Office Action Summary	Application No. 10/624,333	Applicant(s) VAN GOMPEL ET AL.	
	Examiner Keshia Gibson	Art Unit 3761

DETAILED ACTION

Fig. A: Examiner's mark-up of Nakahata's Fig. 2.

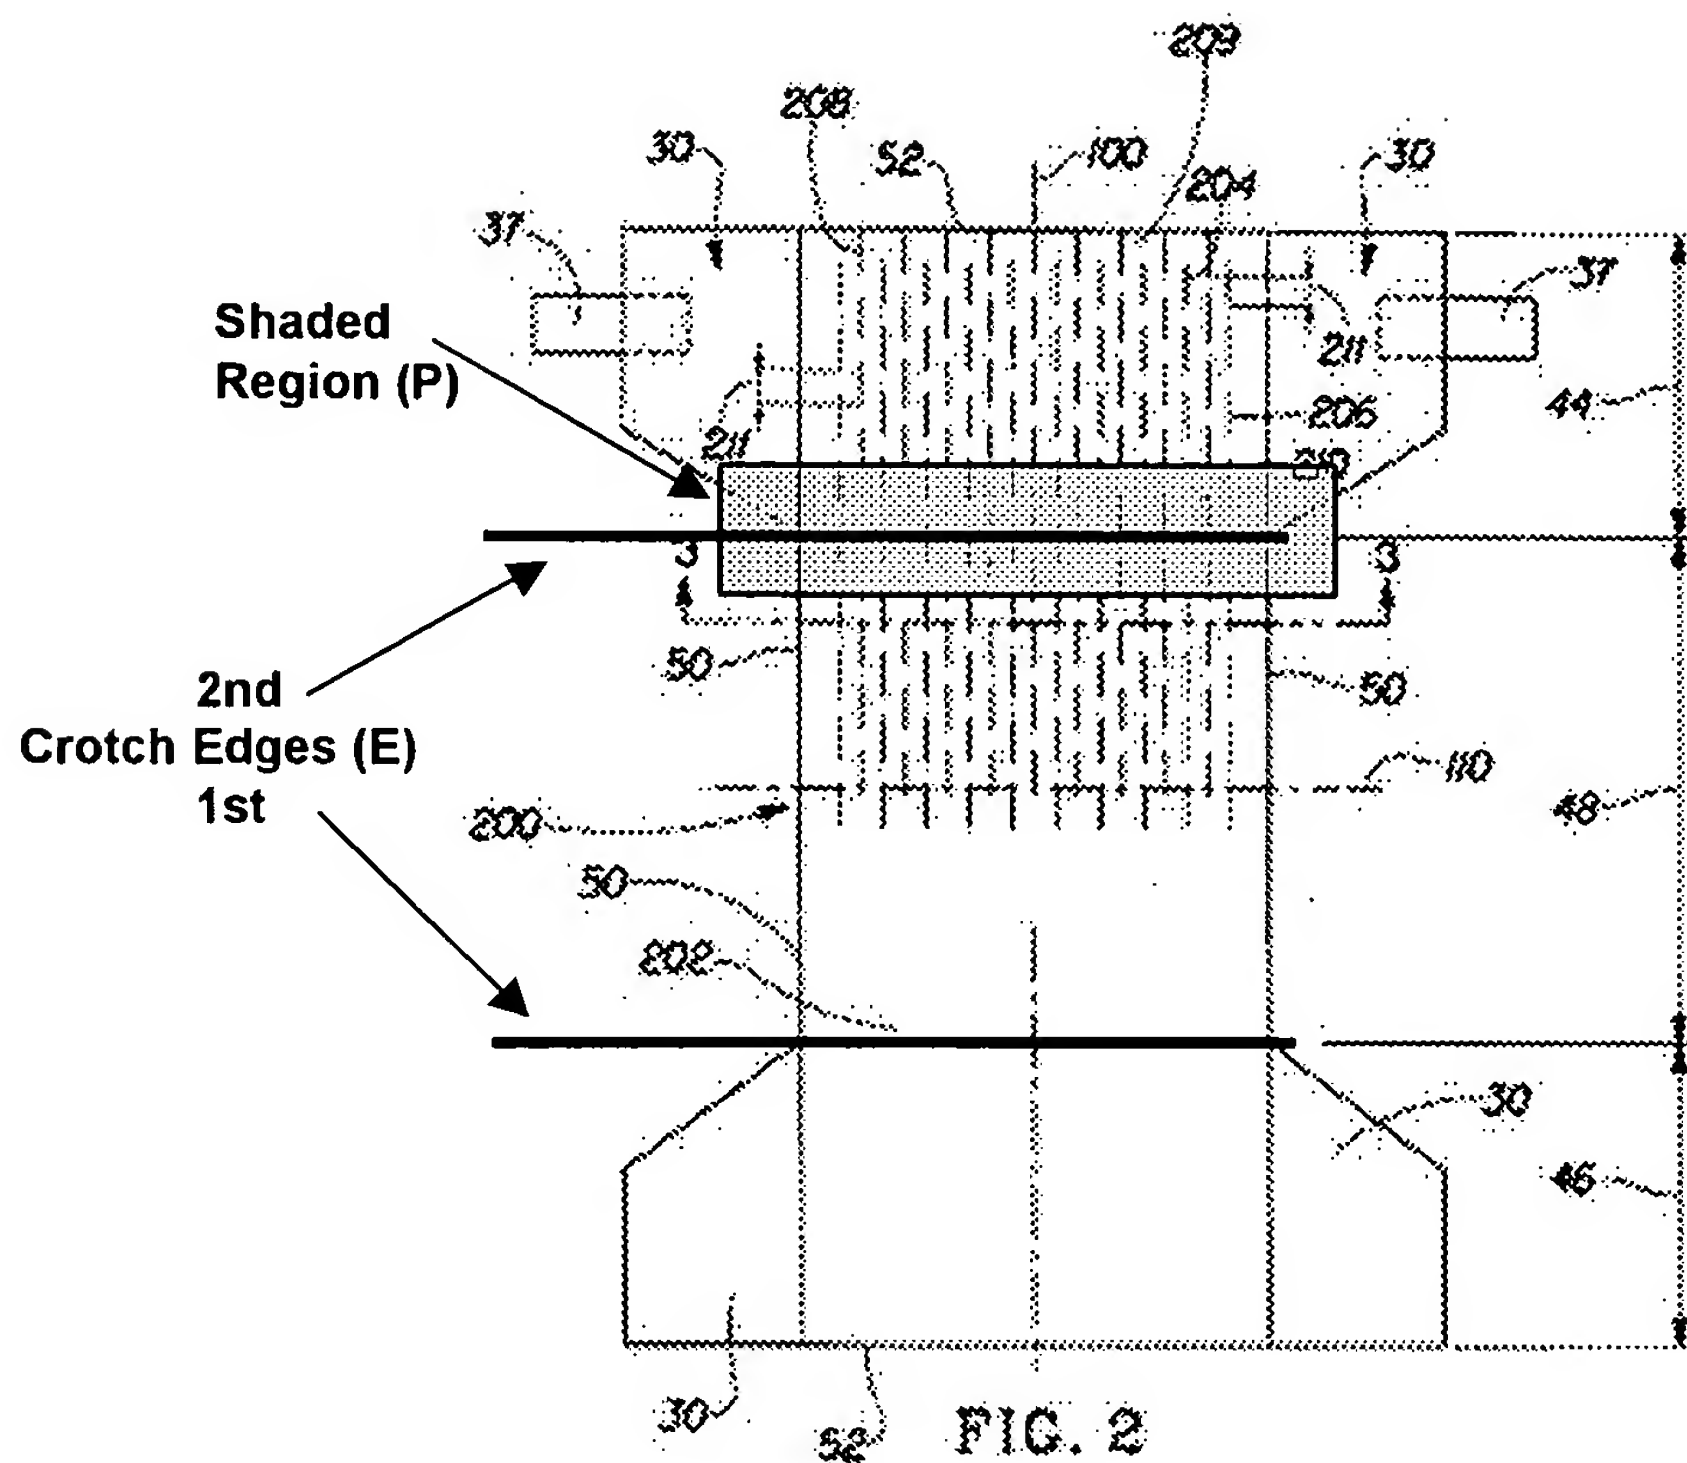
In regard to Claim 1, Nakahata discloses a disposable undergarment 20/200 comprising a front body panel 46, a rear body panel 44, and a crotch member 48 (Figs 1-2; column

3, lines 13-31). The front body panel 46 comprises a pair of opposite first laterally spaced side edges 50, a first waist edge 52, and a first crotch edge E longitudinally spaced from said first waist edge 52; the rear body panel 46 comprises a pair of opposite laterally spaced second side edges 50, a second waist edge 52, and a second crotch edge E longitudinally spaced from said second waist edge E (Fig. 2 and Fig. A below; column 3, line 13-31). The first and second crotch edges E are longitudinally spaced from each other (Fig. A). The second crotch edge E comprises at least one longitudinally extending slit 206 formed therein (see region P in Fig. B below; column 11, lines 1-29). A crotch member 48 is connected to the front and rear body panels 46, 44 and further comprises slits 206 (Fig. 2; column 11, lines 1-29). When viewing the undergarment 20 from the garment-facing surface 26, the crotch member 48 covers the slit(s) 206.

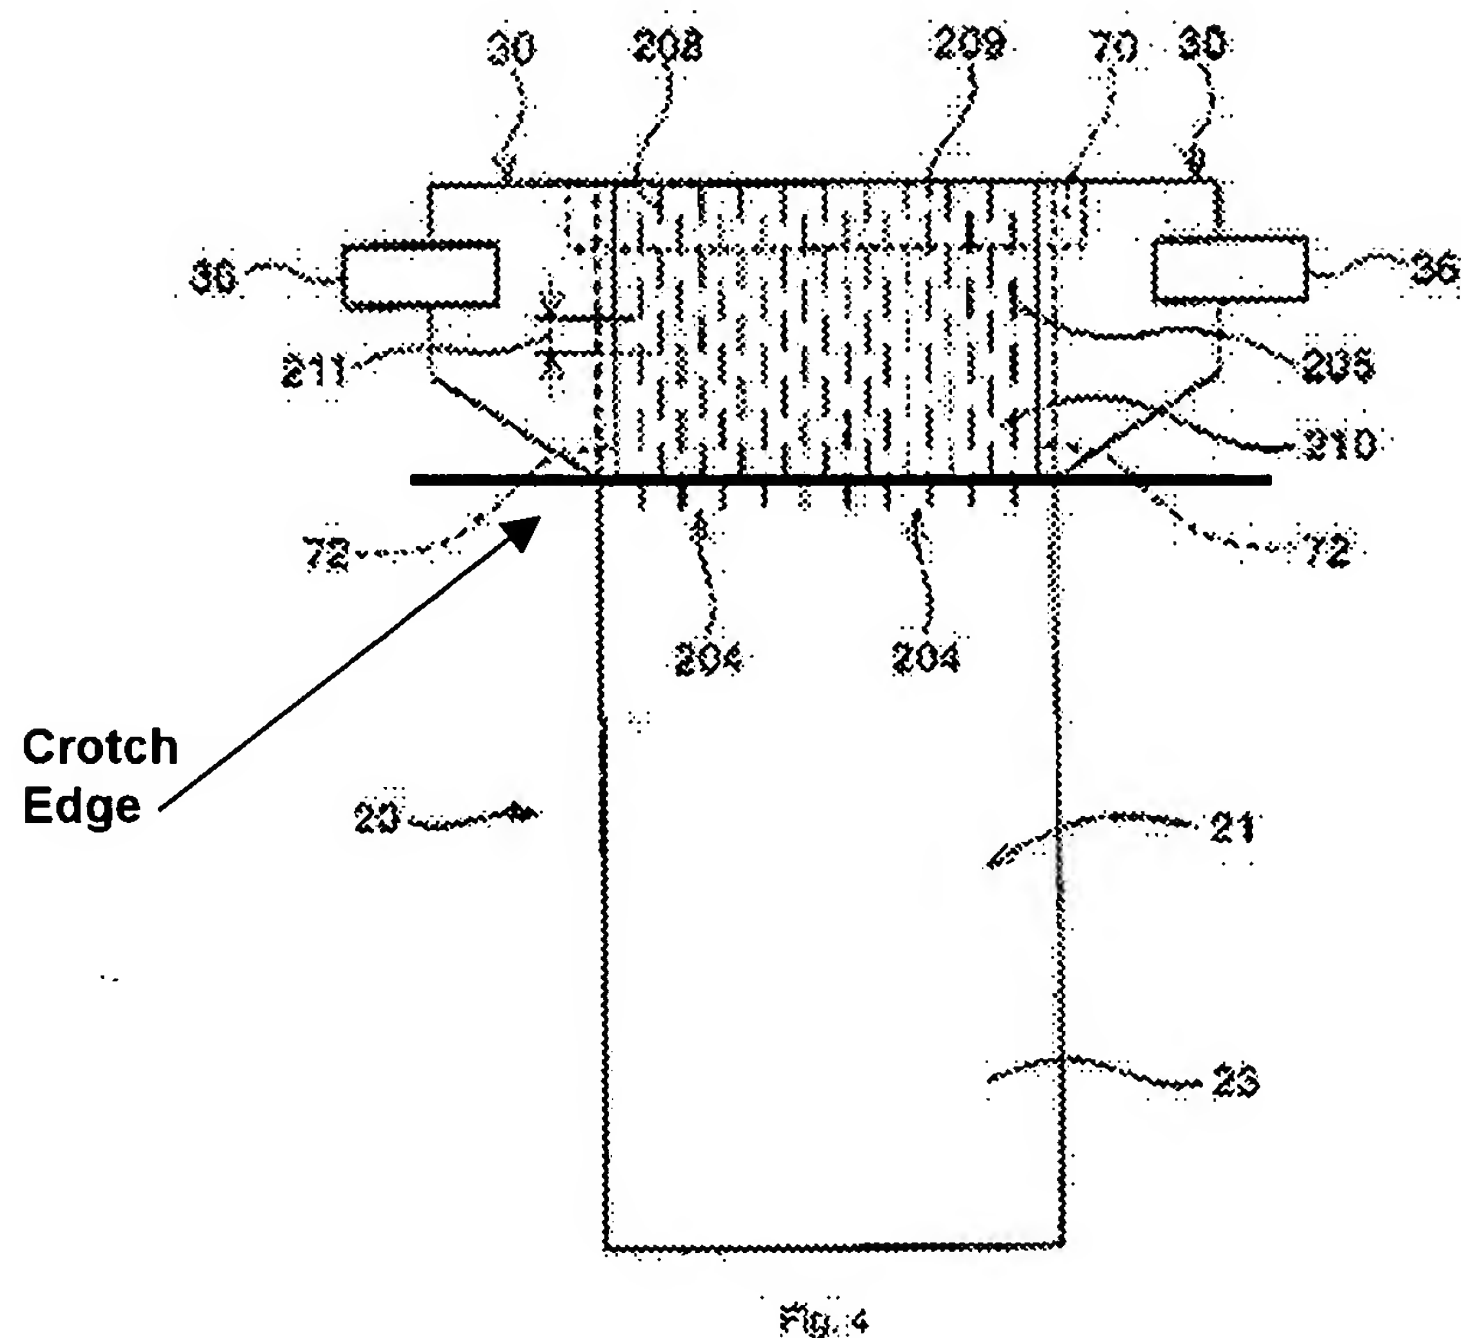
In regard to Claim 1, Nakahata et al. disclose a disposable undergarment 20 comprising a front body panel 45, a rear body panel 43, and a crotch member 47. The front body panel 45 comprises a pair of opposite first laterally spaced side edges 50, a first waist edge 52 and a first crotch edge (dotted line between front body panel 45 and crotch panel 47 in Fig. 2) longitudinally spaced from said first waist edge 52 (Figs. 1-2). The rear body panel 43 comprises a pair of opposite laterally spaced second side edges 50, a second waist edge 52 and a second crotch edge (dotted line between rear body panel 43 and crotch panel 47 in Fig. 2) longitudinally spaced from said second waist edge 52 (Figs. 1-2). The first and second crotch edges are longitudinally spaced from each other (Fig. 2). The second crotch edge comprises at least one longitudinally extending slit 206 formed therein (Figs. 4-6; Fig. B below). The crotch member 47 connected to the front and rear body panels 45, 43 and covers at least one of the slits 206 (Figs. 1-2, Fig. B

below). When viewed for the body-facing surface (such as in Fig. 1), the crotch member covers the slits 206.

In regard to Claim 6, Nakahata discloses that the rear body panel 45 comprising slits 206, further comprises a back sheet 21 made of an elastic material (Figs. 4-6 and Fig. B; page 6, lines 30-31). The rear body panel 45 is expandable between at least a first and second condition Fig. 4, Fig. 5, wherein a pair of edges defining the slit 206 are substantially abutted when the rear body panel 45, comprising an elastic material, is in
